### **Stratford Coal Extension Project - SSD 4966**

Following are comments and recommendations concerning the Stratford Coal Extension Project and the associated Environmental Impact Statement. This submission is made in our capacity as owners of a rural property at 314 Glen Rd Craven that would be adversely affected by aspects of the project as currently proposed.

Map showing location of potential alternative offset areas : Ex Billins & Ex Allman properties

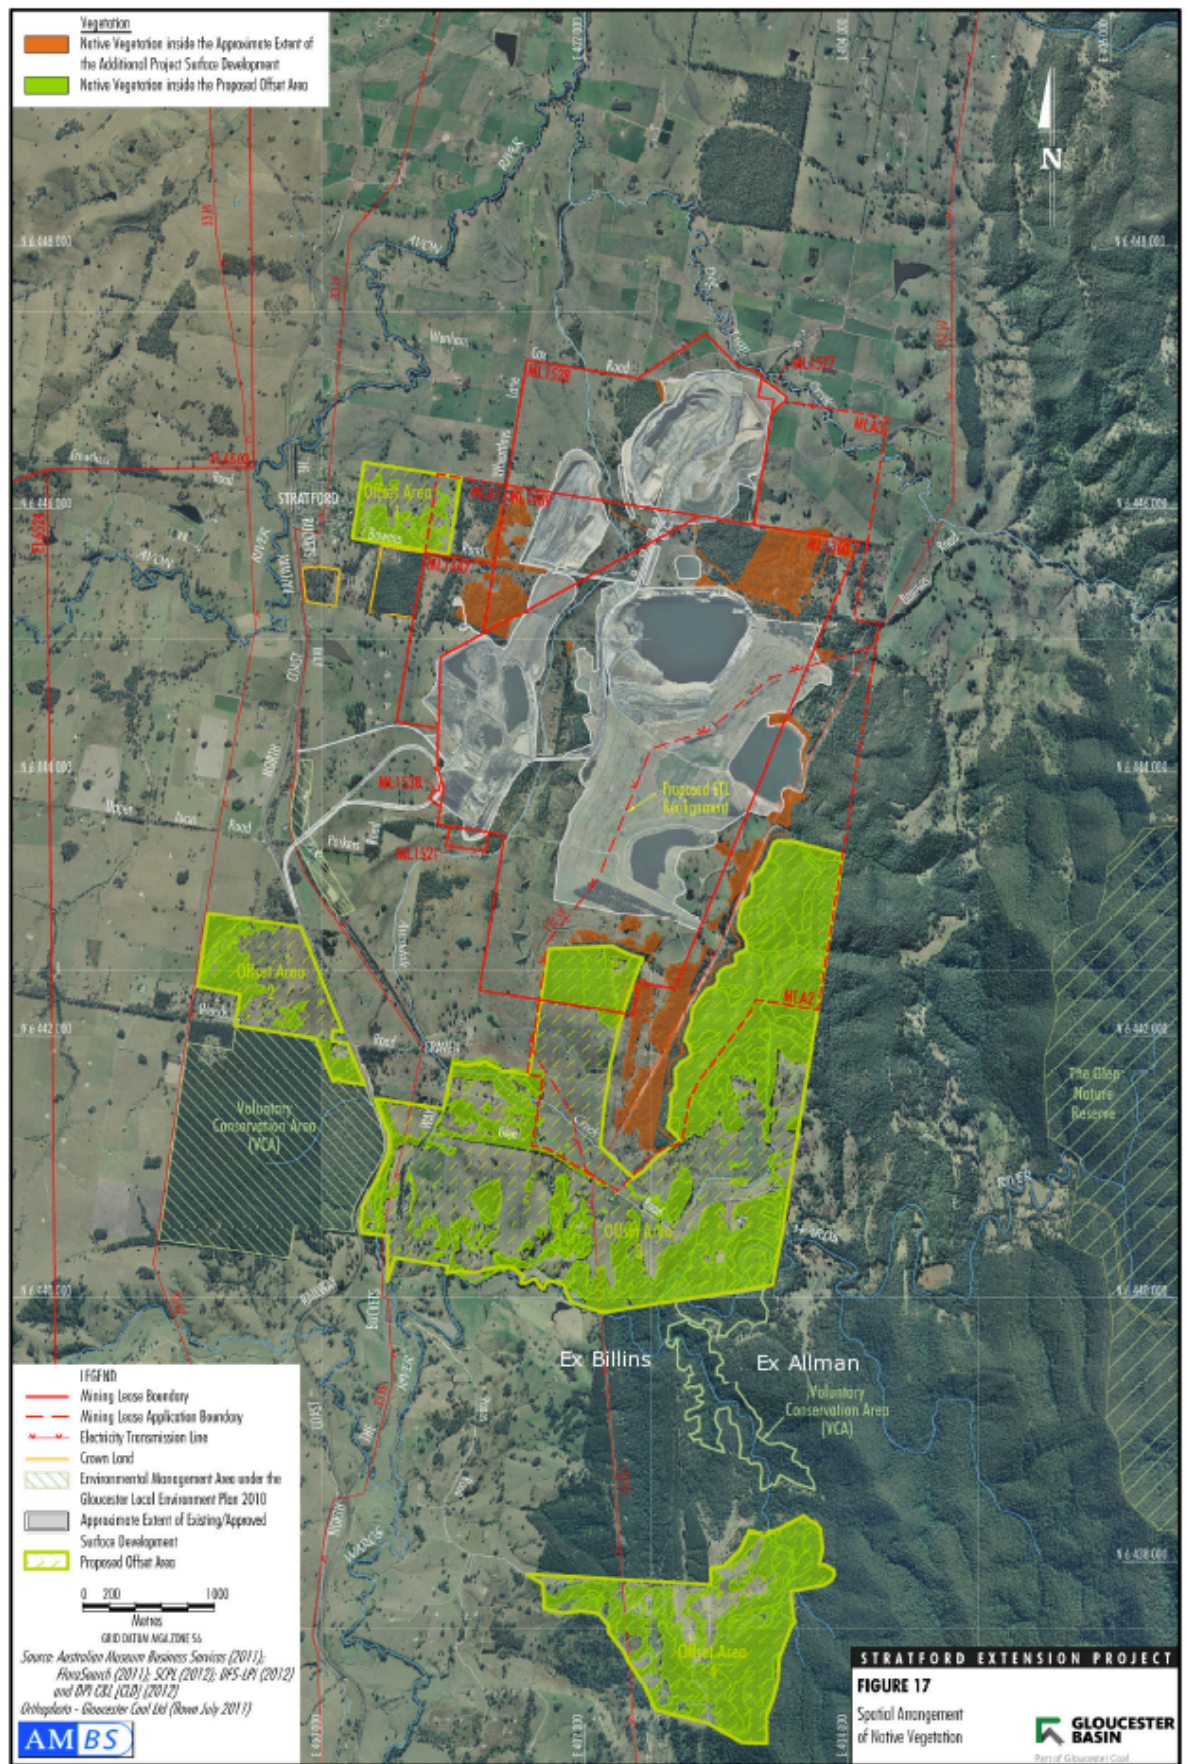
Other areas of land already owned by SCPL would better offset the biodiversity impacts of the project and should be substituted for the proposed Offset Area 1. Areas that should be considered as alternatives include the ex-Allman property that links offset areas 3 and 4 and the northern portion of the ex-Billins property that adjoins offset area 3. Both of those properties are within the Craven Valley corridor. They contain areas of forest and woodland similar in age structure to that proposed to be cleared for the Stratford East open cut and areas of moderate tree-hollow density. Use of the ex -

Allman property as an offset would provide the additional benefit of practical contiguity between offset areas 2, 3 and 4. The currently proposed offset area 1 does not link to any of the other proposed offset areas.

The location of those potential offset areas is shown in the figure at the end of this section.

- Alternative areas to be considered as offset areas should include the ex-Billins and ex-Allman properties that adjoin offset area 3.
- Final acceptance of the proposed offset areas should be made conditional on Yancoal expressly ruling out future mining or exploration by Yancoal (or connected companies) in the offset areas.
